**Iowa Department of Transportation Highway Division**

STANDARD DESIGN - 30' ROADWAY, SINGLE SPAN BRIDGE

**PRETENSIONED PRESTRESSED CONCRETE BEAM BRIDGES**

**SUPERSTRUCTURE DETAILS H30SI-02-12**

### CONCRETE SEALER LIMITS FOR OPEN RAILS

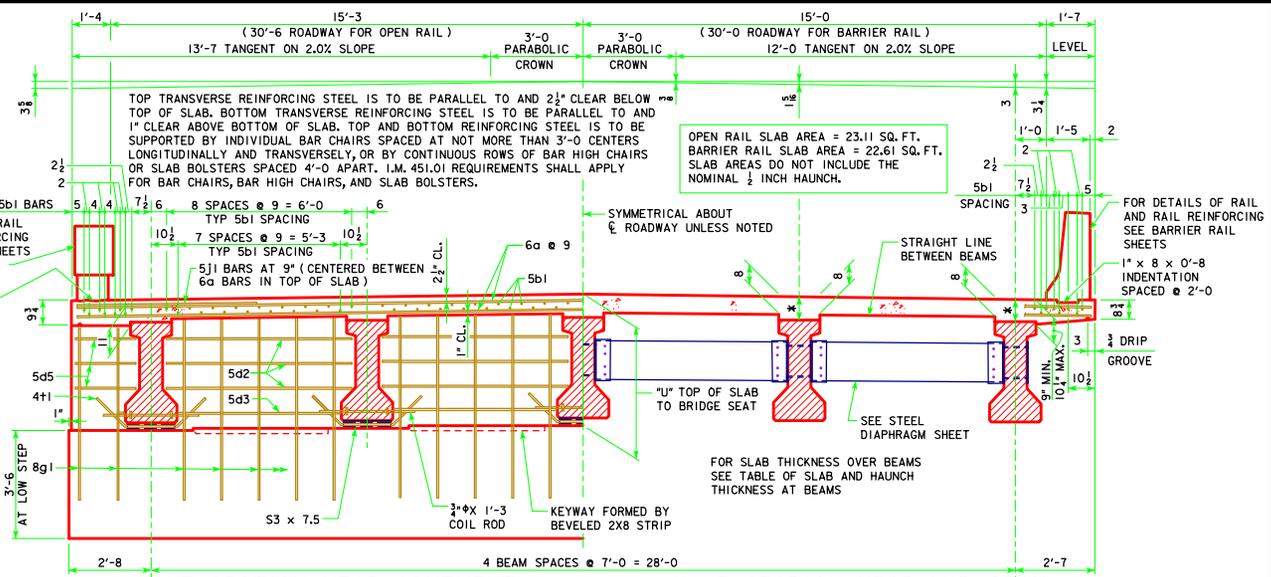
REVISED 06-12 - I.M. REQUIREMENT ADDED TO BAR CHAIR NOTE. CONCRETE SEALER AREA CHANGED AND SEALER NOTES WERE CHANGED.

CONCRETE SEALER SHALL BE APPLIED TO BOTH SIDES OF BRIDGE SLAB ON THE TOP, EDGE OF SLAB AND UNDER THE SLAB. THE CONCRETE SEALER SHALL ALSO BE APPLIED TO THE OPEN RAIL ON THE TOP, TRAFFIC FACE SIDE, BOTTOM OF RAIL, AND ON ALL SIDES OF THE OPEN RAIL POSTS.

THE CONCRETE SEALER LIMITS ARE SHOWN IN THE DETAIL AND SHALL APPLY TO THE FULL LENGTH OF BRIDGE. CONCRETE SEALER SHALL BE APPLIED IN ACCORDANCE WITH ARTICLE 2403.03, P. 3, OF THE STANDARD SPECIFICATIONS.
